09 February 2026

211541 CAAL

173-179 Walker Street, North Sydney

Proposed Changes to Early Works Stormwater Diversion (SSD-67175465)

DRAWING NAME:
SITEWORKS AND STORMWATER
MANAGEMENT PLAN,
SHEET 3

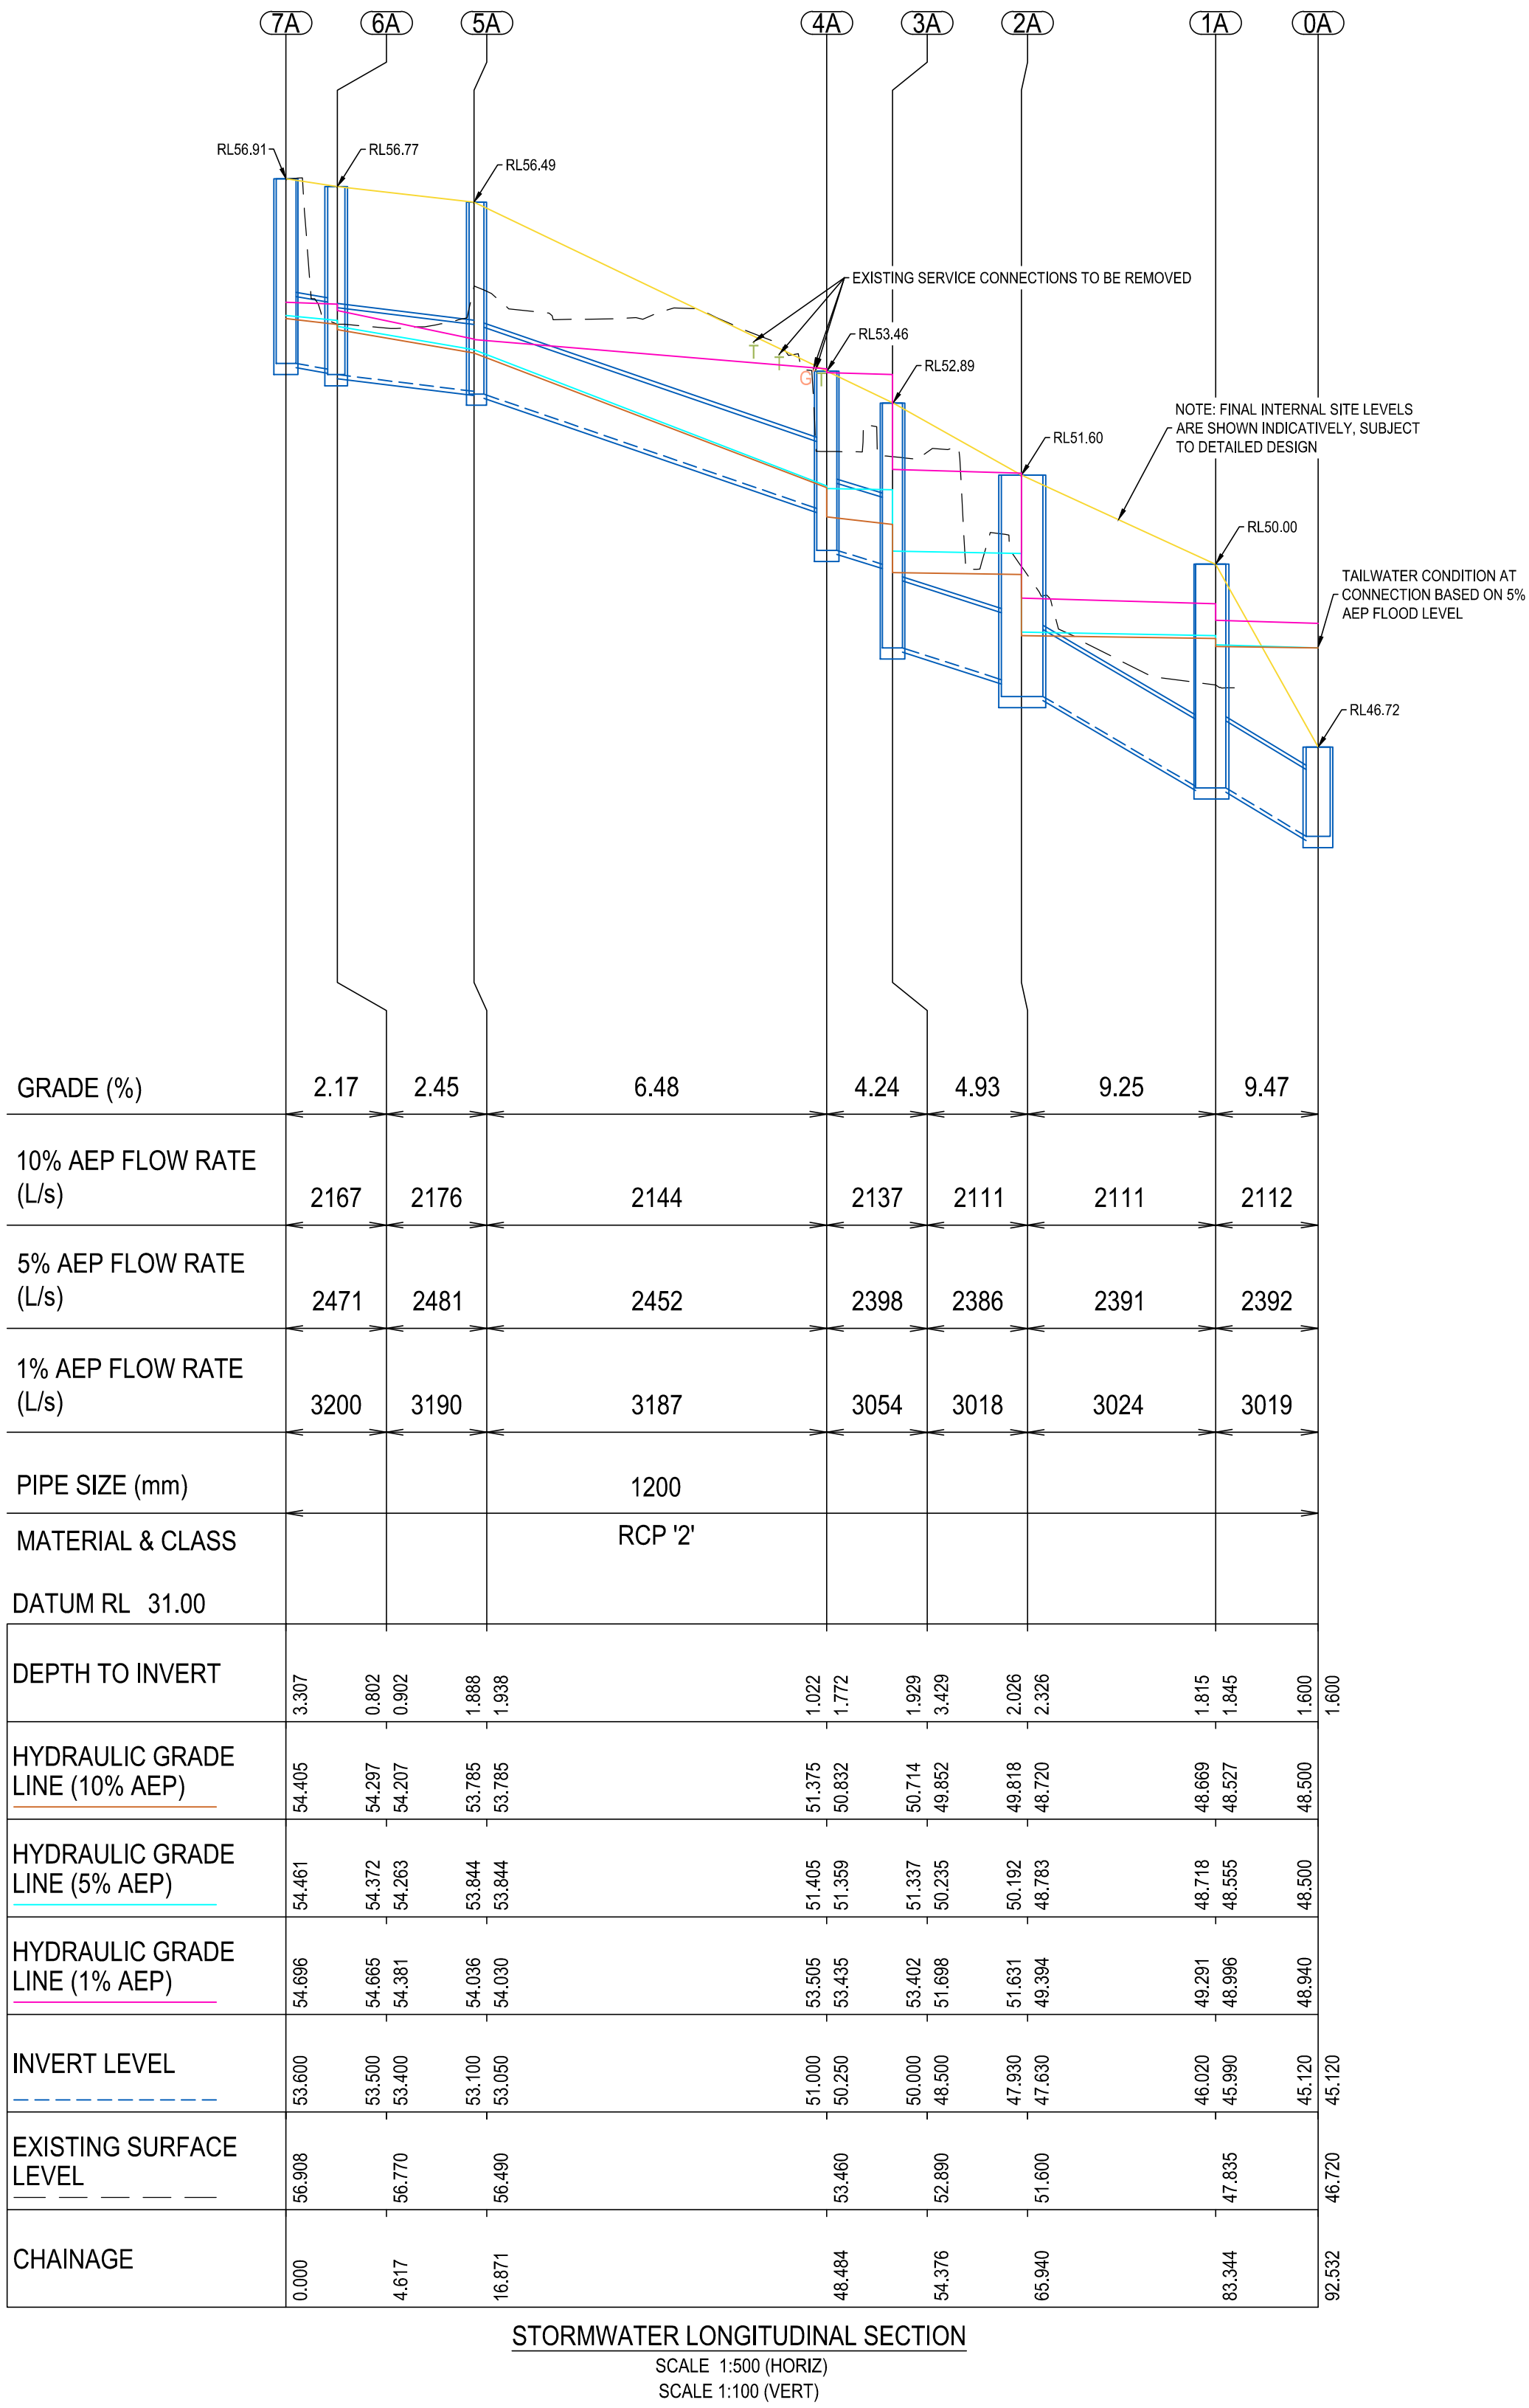
1. Relocation of Proposed 5-Grate/Lintel Pit with Stone Inlet (Pit 7A)

Site investigations have confirmed that the existing 860mm × 1000mm box culvert traverses the site in a perpendicular alignment to the retaining wall, rather than the diagonal alignment shown on the original survey. To reflect the confirmed culvert alignment, reduce on-site construction complexity, and utilise existing pits to achieve a direct connection, it is proposed to relocate Pit 7A directly over the existing box culvert.

This revision removes unnecessary pipework and transitions and allows the pit to function as intended, without introducing any additional structural or hydraulic risk. The relocation of this pit and retention of the existing sag inlet pit to the south matches the intake capacity of the previously submitted design.

2. Modification of Pit 6A

As a result of the revised location of Pit 7A and the confirmed alignment of the existing pipe through the site, Pit 6A has been adjusted to suit the updated pit and pipe arrangement. This ensures continuity of the stormwater system and appropriate pipe alignments are maintained.

3. Relocation of Stormwater Diversion Within the Site Boundary

The stormwater diversion alignment has been revised to be located within the site boundary parallel to Hampden Street (the previous proposal had the pipe within and along the centre of Hampden Street). This change avoids known clashes with existing infrastructure within the public road reserve and eliminates the need for relocation and coordination with third-party service authorities.

4. Replacement of Kerb Inlet Pits with Grated Drains

It is proposed to replace the previously approved four kerb inlet pits along Hampden Street with two 300mm wide grated drains, each 7.0m in length, providing a total inlet length of 14.0m. Each of the grated drain is proposed to have a 450 x 600mm surface inlet pit at the end, discharging via a proposed 375mm diameter outlet.

STORMWATER LONGITUDINAL SECTION

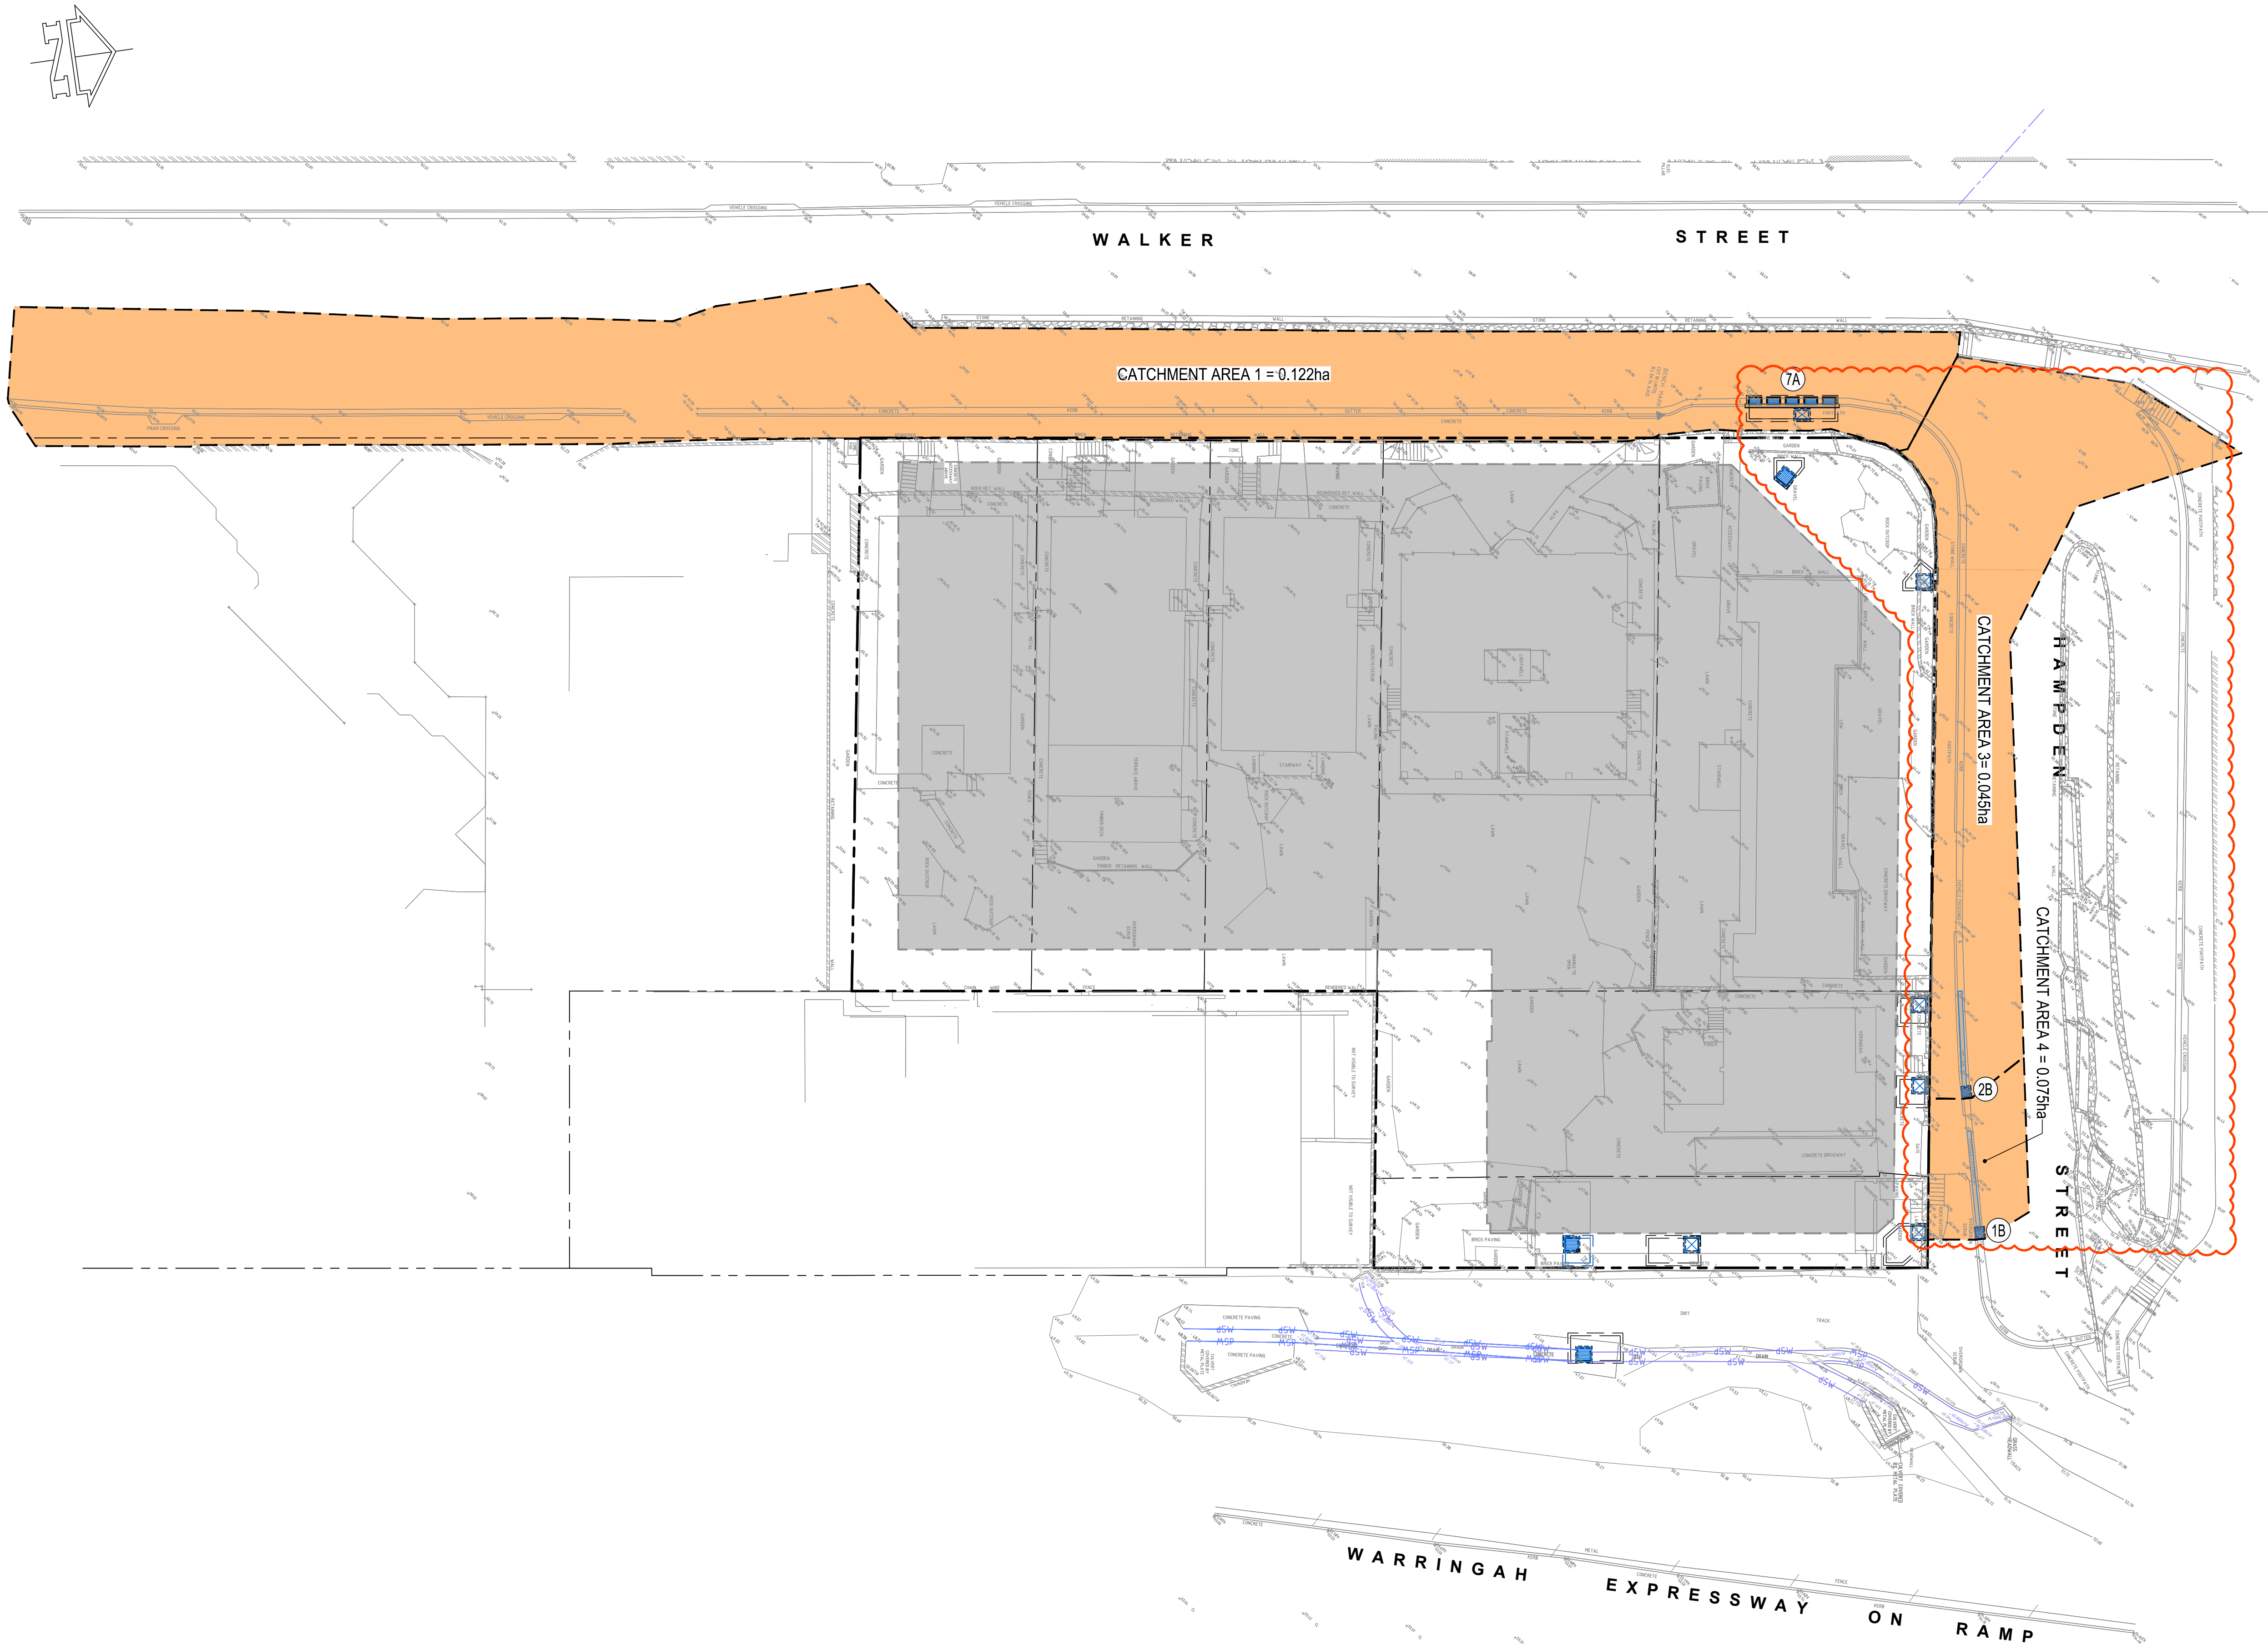
By matching the previous submitted pipe size, there is no loss of hydraulic capacity of the system with this change.
